Minimoog Model D factory mod made to most tempco style VCO boards.

Adds a delay line that improves tracking.

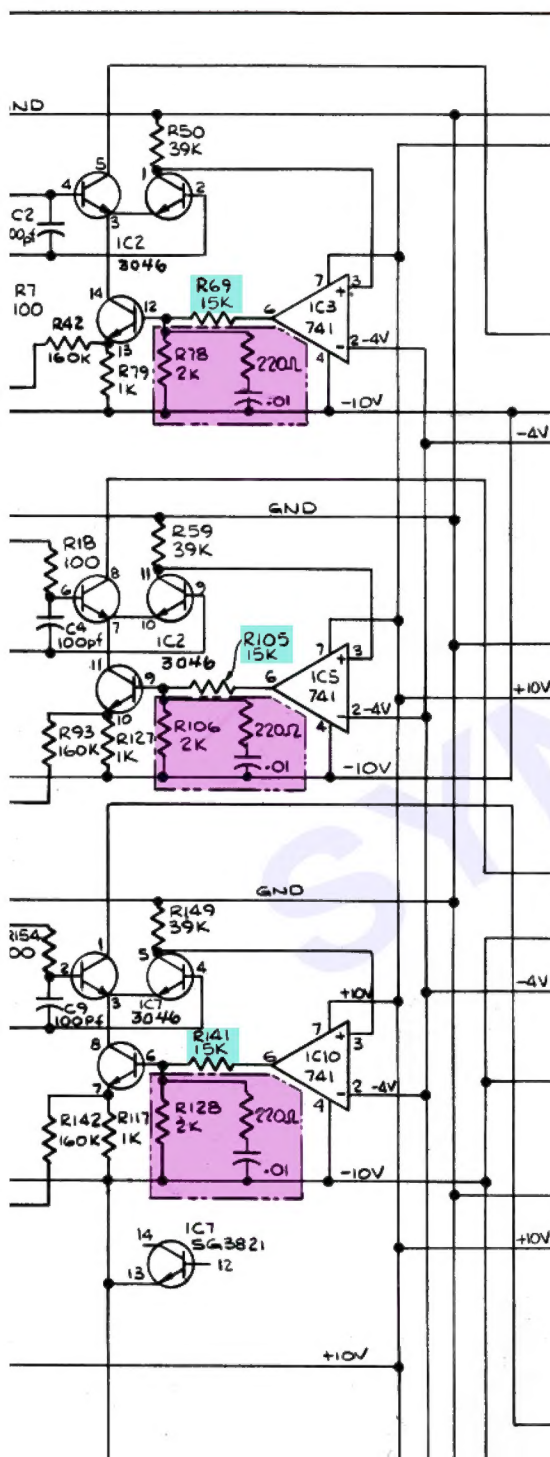
Requires replacement of 3 resistors with 15K and wiring of additional 3 resistors and 3 capacitors across R78, R106 & R128.

R69, R105 & R141 previously 6.8K. Change all to 15K

R78, R106 & R128 remain as 2K, but parallel 220 ohm and .01 capacitor
